Project: River Road Elementary School – Building and Site Construction
Title: Addendum No. 1
Contract No: CIP 410 307 001
Date: March 1, 2016
From: John Stapleton, PIVOT Architecture
To: Interested Bidders

This Addendum is available at <http://www.4j.lane.edu/bids/> and modifies the Project Manual, Specifications, and Drawings in accordance with the Invitation to Bid and the Instructions to Bidders as follows:

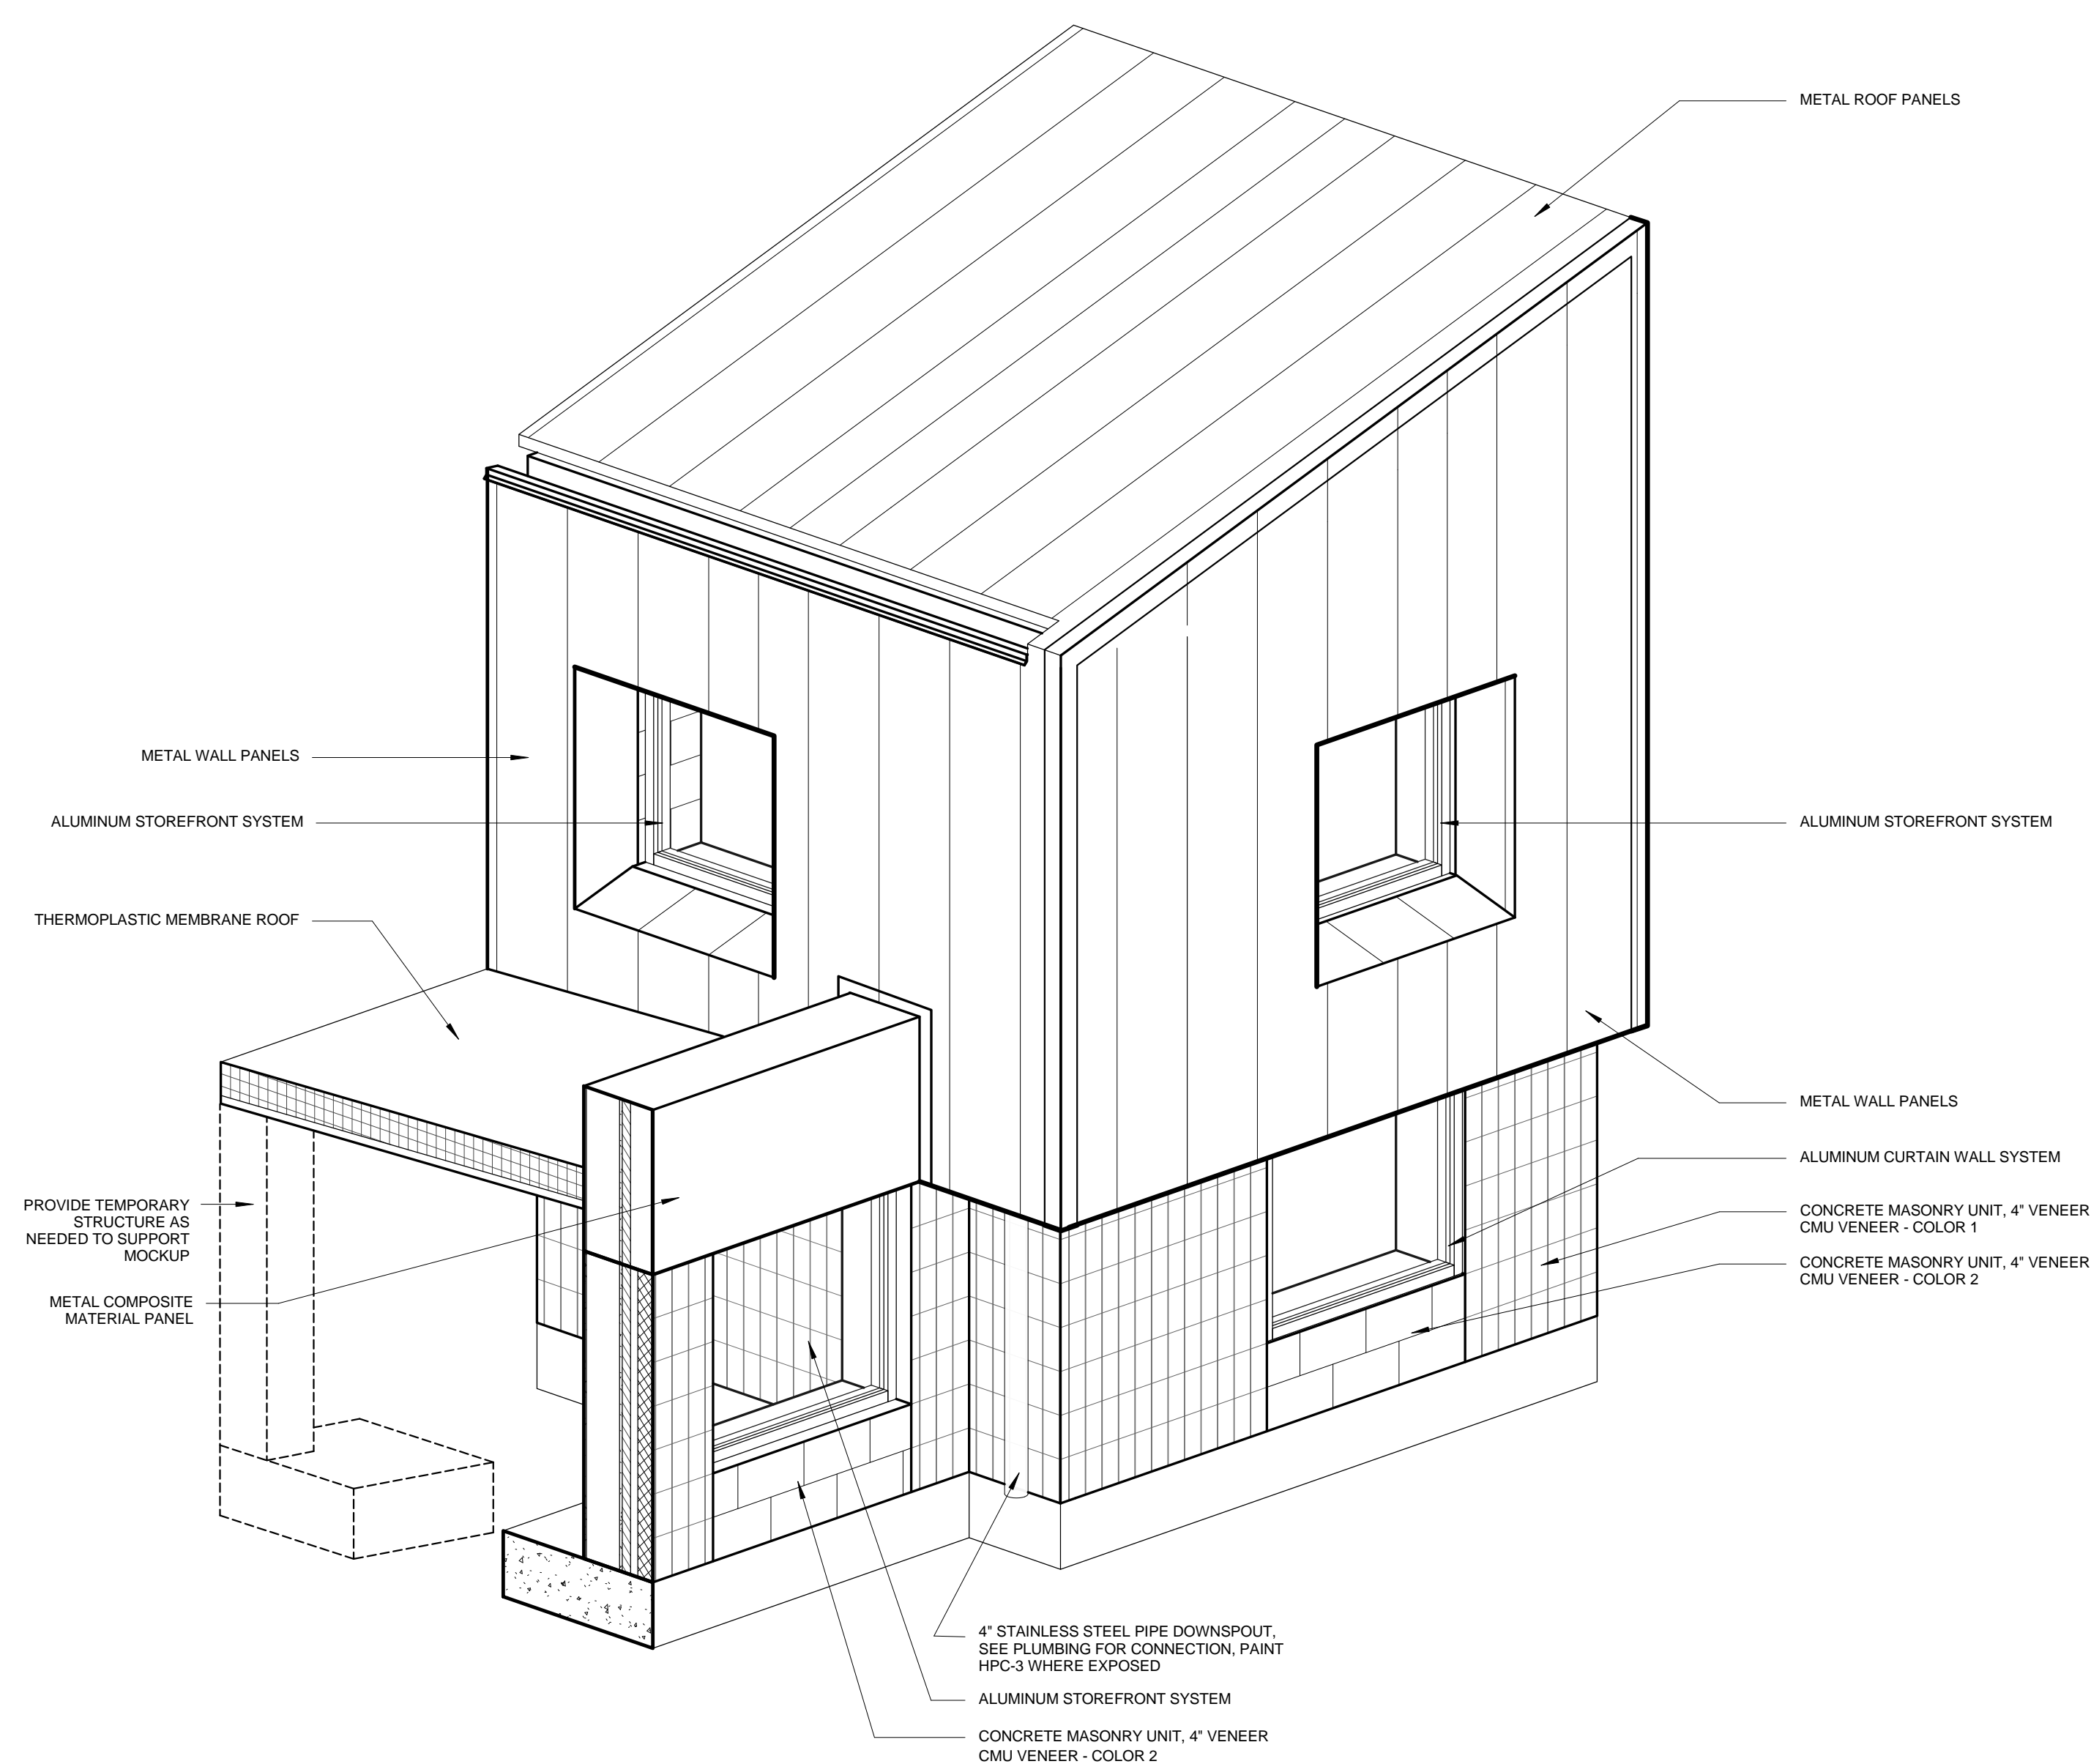
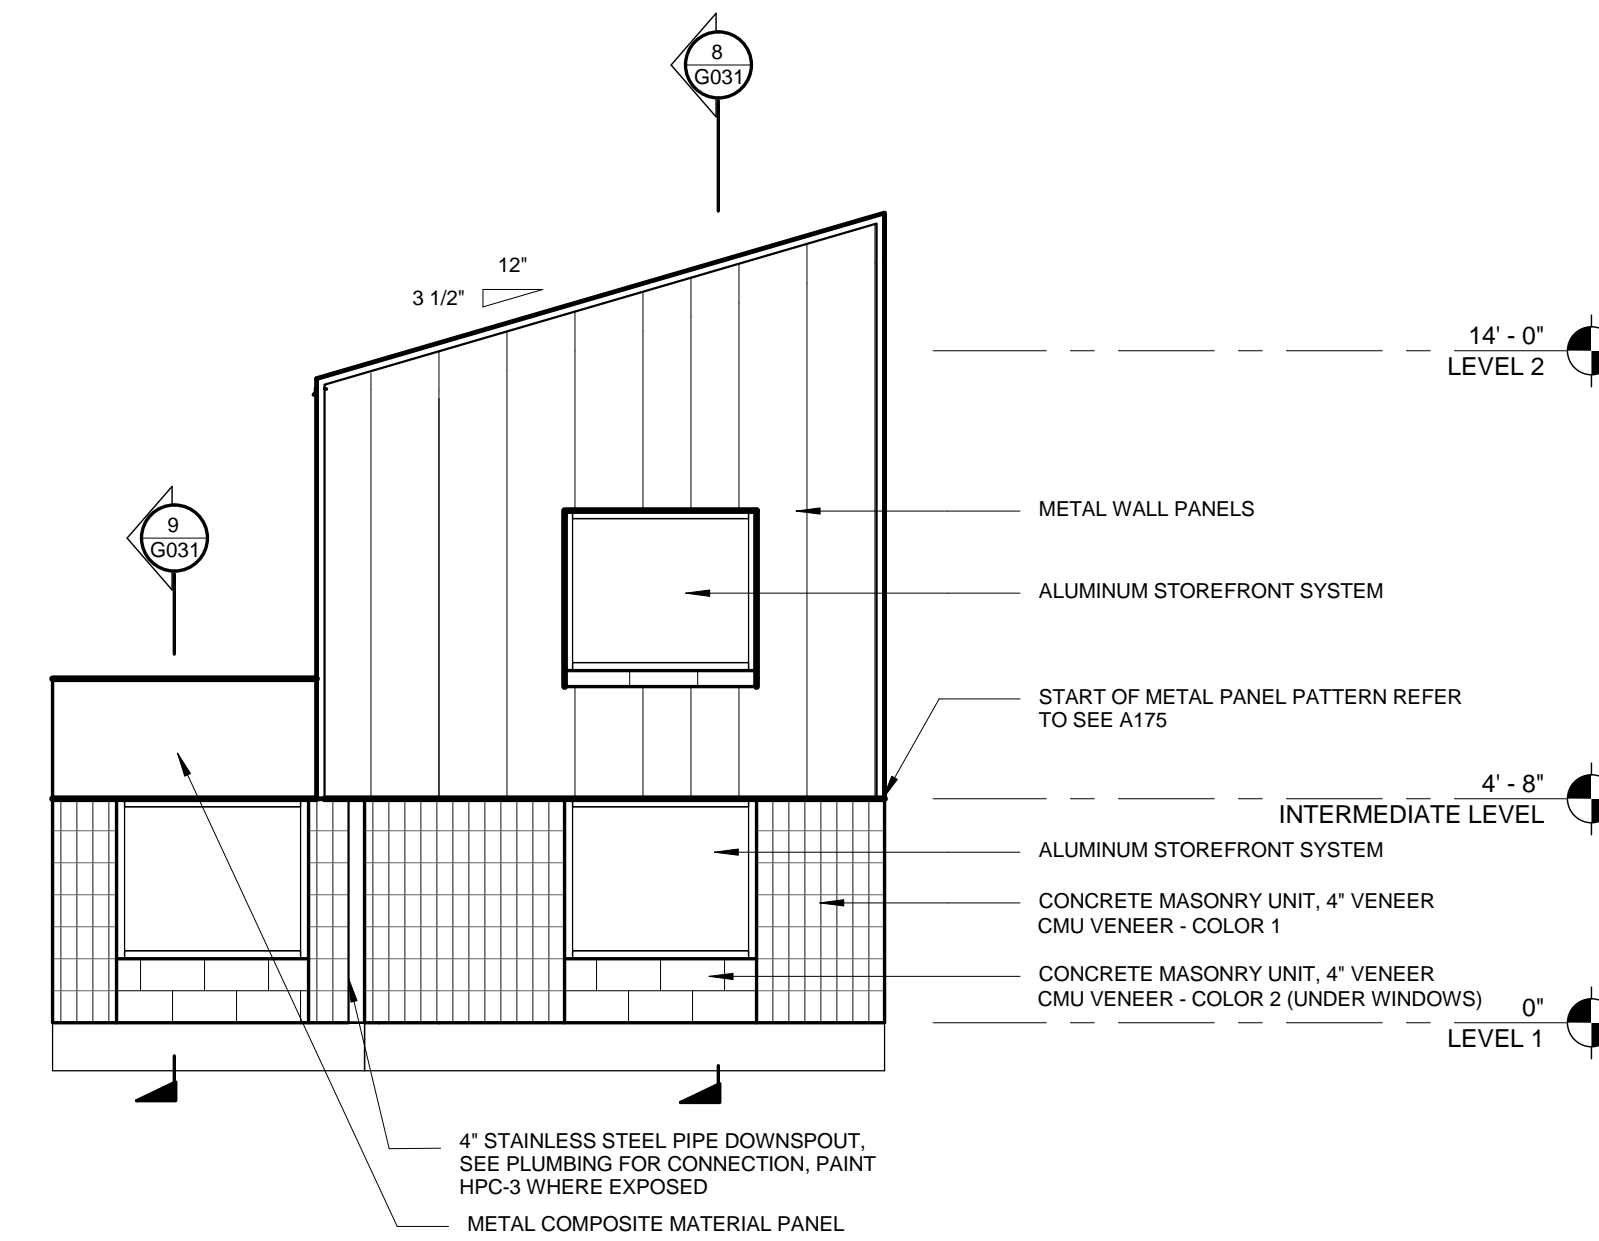
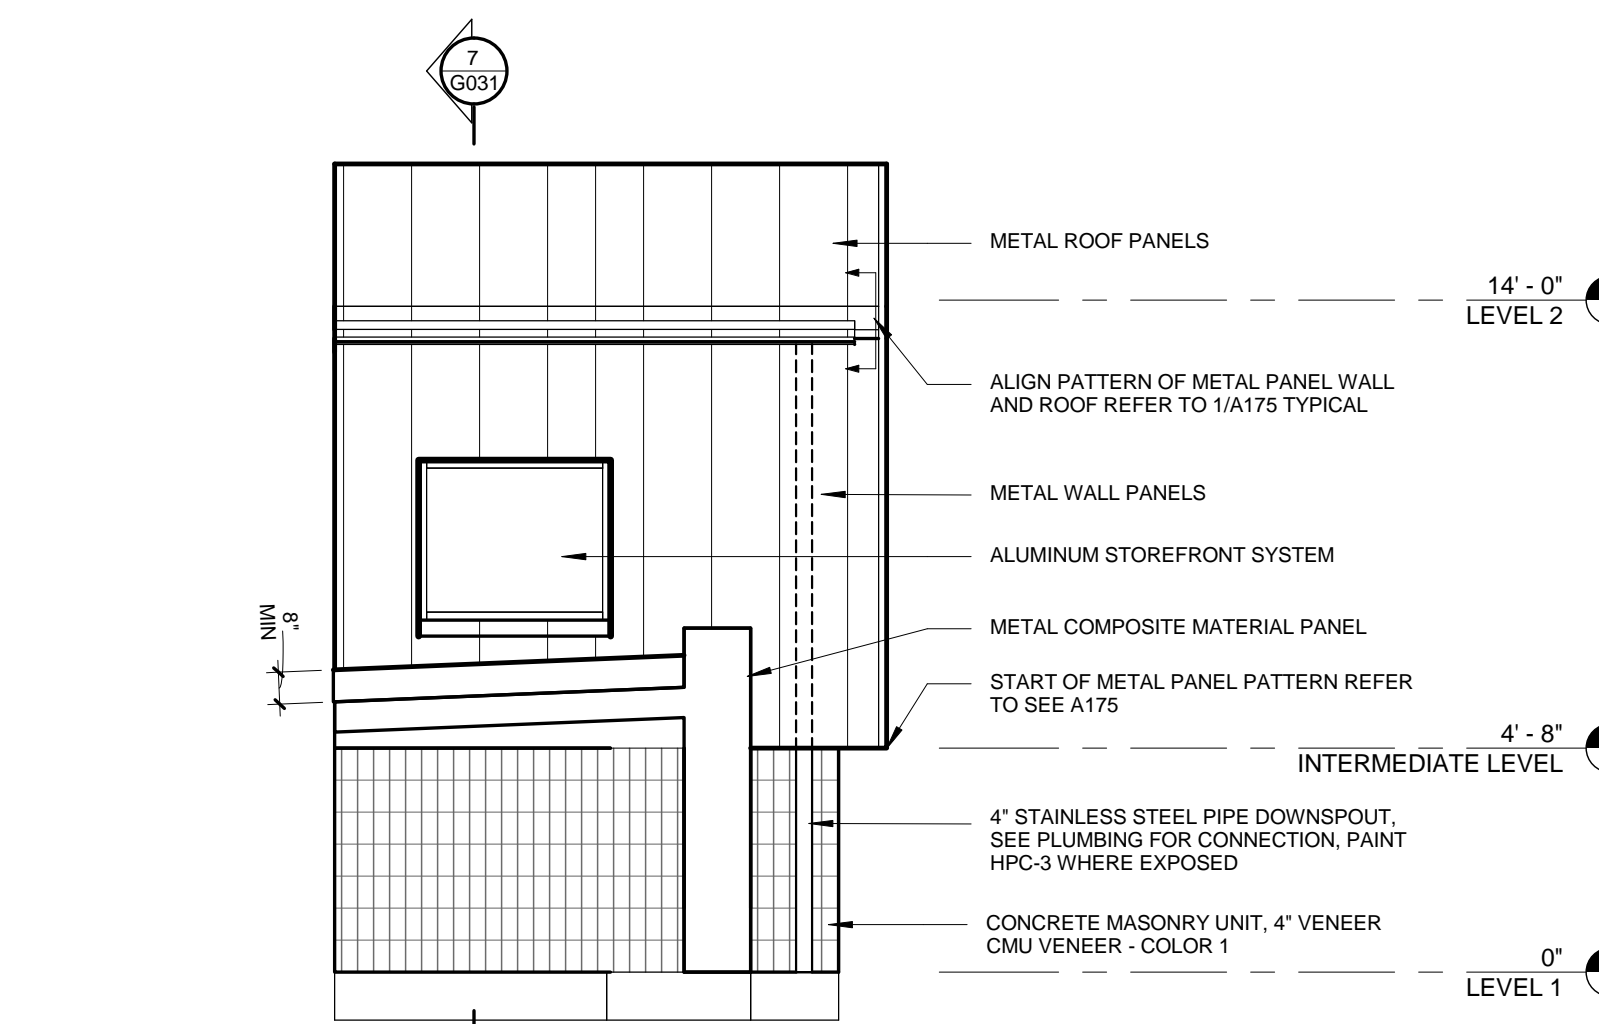
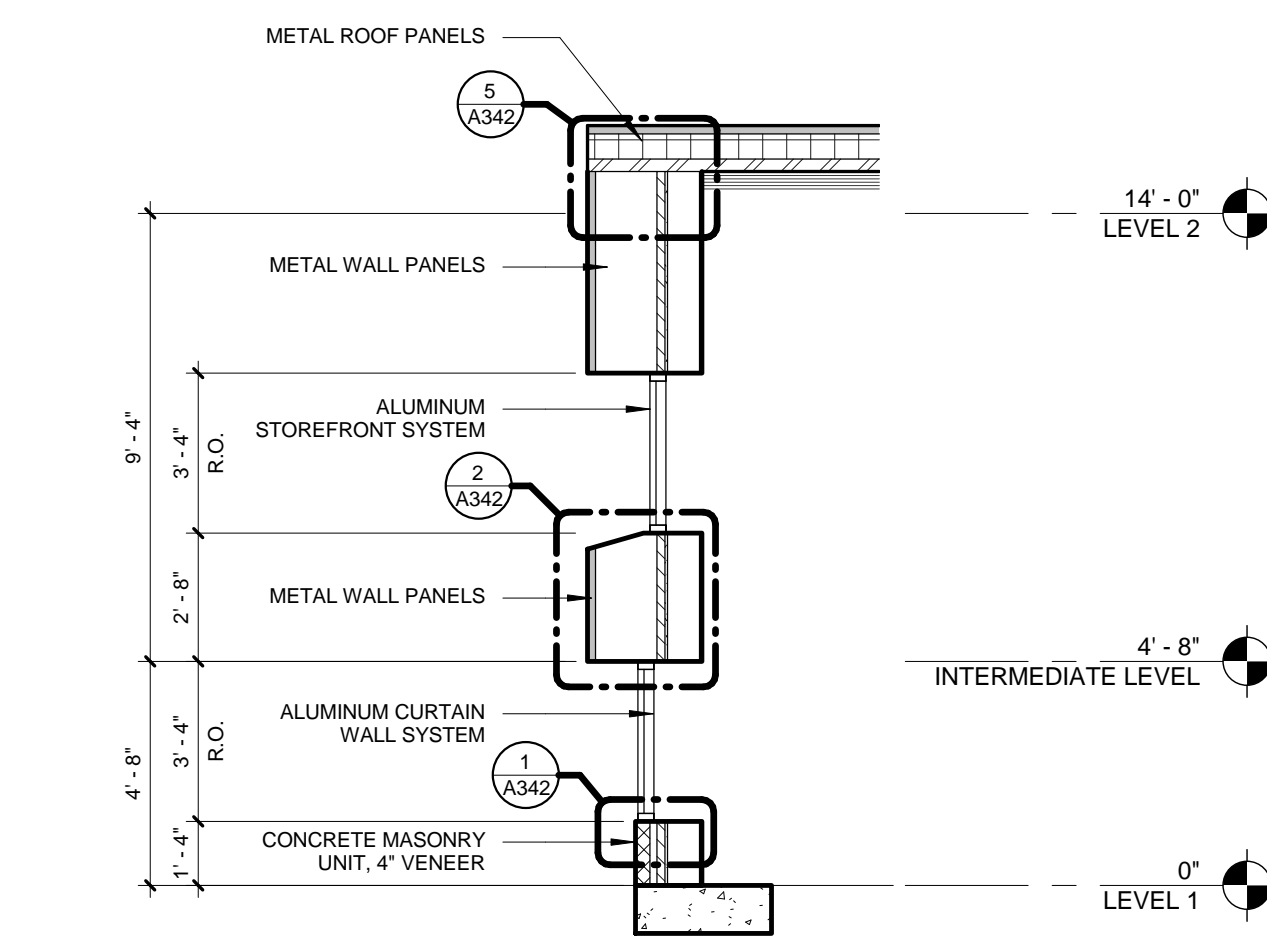
- 1-3-1 Sheet G011. Revised deferred submittal list.
- 1-3-2 Sheet G031. ADD Mockup detail sheet.
- 1-3-3 Sheet A112. Revised plan at elevator, revised keynote.
